SUBJECT: ISSUANCE OF AMENDMENT (TAC NO. 65873)

The Commission has issued the enclosed Amendment No. 16 to Facility Operating License No. NPF-49 for Millstone Nuclear Power Station, Unit No. 3, in response to your application dated July 31, 1987.

AMENDMENT TO FACILITY OPERATING LICENSE

Amendment No. 16
License No. NPF-49

FIGURE 4.7-1
SAMPLE PLAN 2) FOR SNUBBER FUNCTIONAL TEST

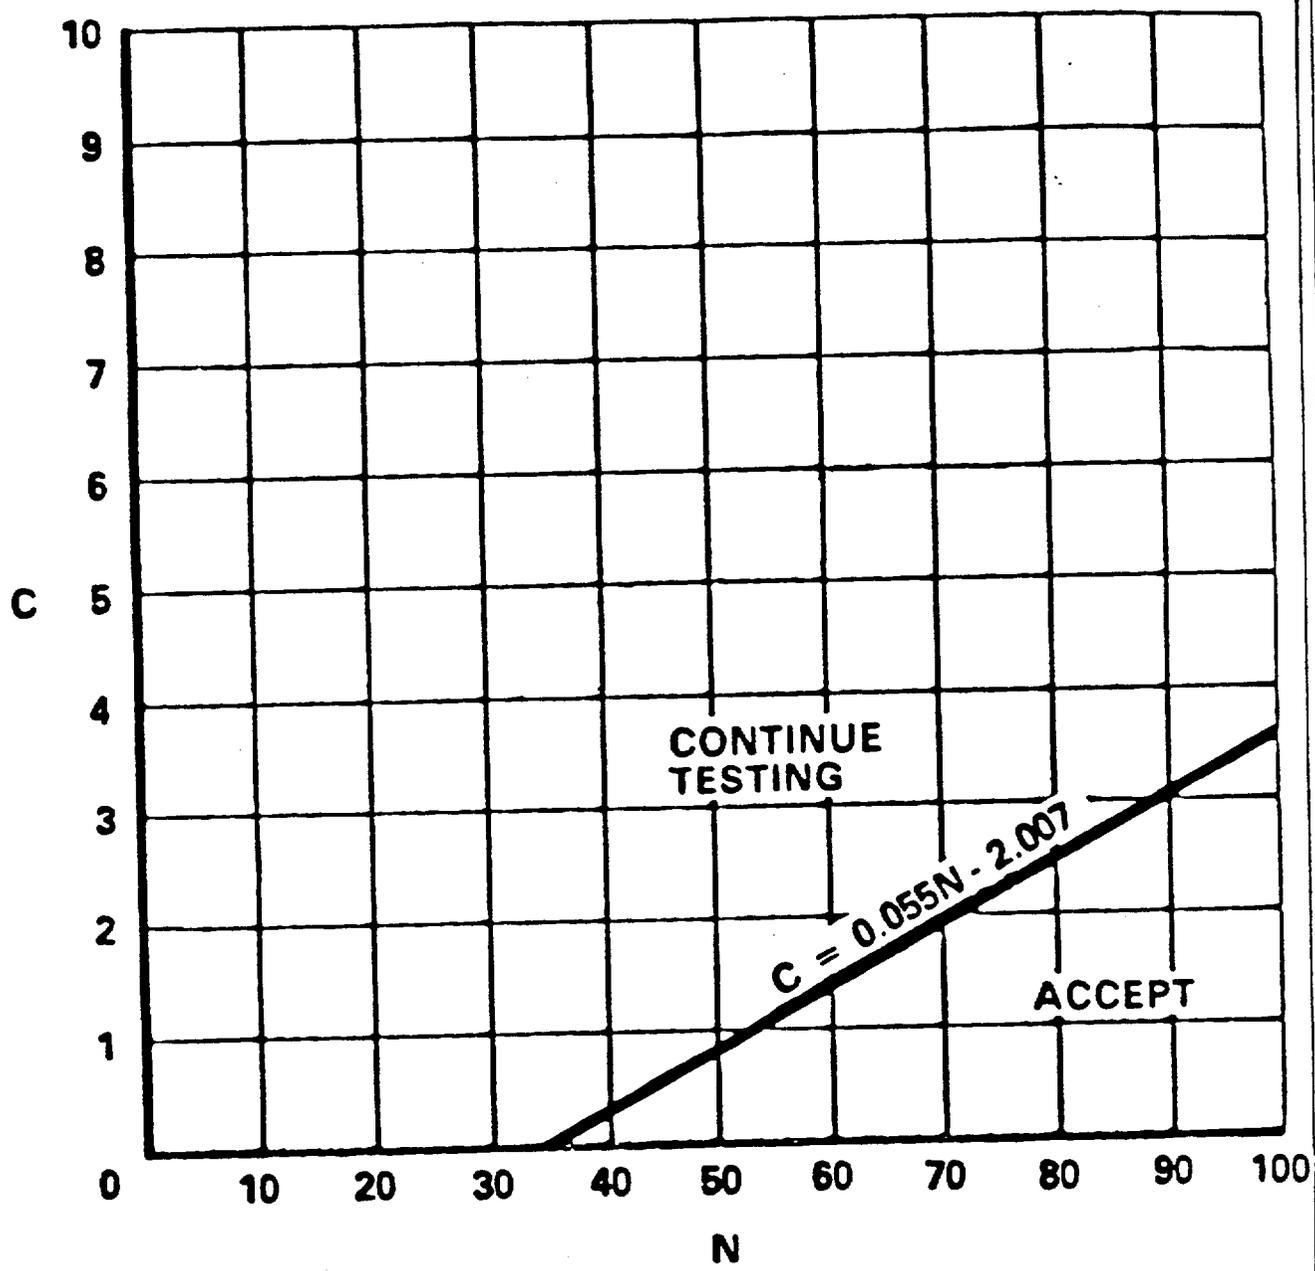
The proposed changes to Technical Specification Section 4.7.10.e.2) (Functional Tests) and Figure 4.7-1 "Sample Plan No. 2 for Snubber Functional Test" will delete the "reject" line on Figure 4.7-1. Figure 4.7-1 provides the acceptance criteria method for the functional test results and denotes a "reject" region and a "continue testing" region. If at any time the plotted test results fall within this "reject" region, then all snubbers are to be functionally tested. Surveillance Requirement 4.7.10.e.2) and its accompanying Figure 4.7-1 are being changed to delete the "reject" region on Figure 4.7-1, to substitute an expanded "continue testing" region, and to clarify the manner in which test results should be plotted sequentially in order of sample assignments; (i.e., each snubber should be plotted by its assigned order in the random sample, not by the order of testing). References to the "reject" region in the test of Technical Specification Section 4.7.10.e.2) and Bases 3/4.7.10 are also being deleted.

The acceptance criteria (represented by Figure 4.7-1 in the Technical Specifications) were developed using "Wald's Sequential Probability Ratio Plan". Statistical studies using Wald's sequential sampling plan indicate that a major change in the reject line caused an insignificant change in the accept line or in other words acceptance is independent of rejection. These studies also demonstrate that while the probability of false acceptance of a bad snubber population under the proposed amendment still exists it is negligible. As long as the "reject" line remains in the sample plan there is some possibility of rejecting a good snubber population and consequently requiring an unnecessary 100% functional testing of snubbers with attendant ALARA and safety concerns, manpower utilization and outage extension. The proposed technical specification change will alleviate these problems and still ensure continued or additional testing if snubber quality of failed snubbers is equal to or greater than 5%.

- 2) A representative sample of each type of snubber shall be functionally tested in accordance with Figure 4.7-1. "C" is the total number of snubbers of a type found not meeting the acceptance requirements of Specification 4.7.10f. The cumulative number of snubbers of a type tested is denoted by "N". Test results shall be plotted sequentially in the order of sample assignment (i.e. each snubber shall be plotted by its assigned order in the random sample, not by the order of testing). If at any time the point plotted falls in the "Accept" region, testing of snubbers of that type may be terminated. When the point plotted lies in the "Continue Testing" region, additional snubbers of that type shall be tested until the point falls in the "Accept" region or the "Reject" region, or all the snubbers of that type have been tested; or

The changes proposed by the licensee have been reviewed by the staff and have been found to be acceptable because they will eliminate unnecessary testing of snubbers resulting in reduced man-rem exposure without undermining the effectiveness of the overall surveillance program.
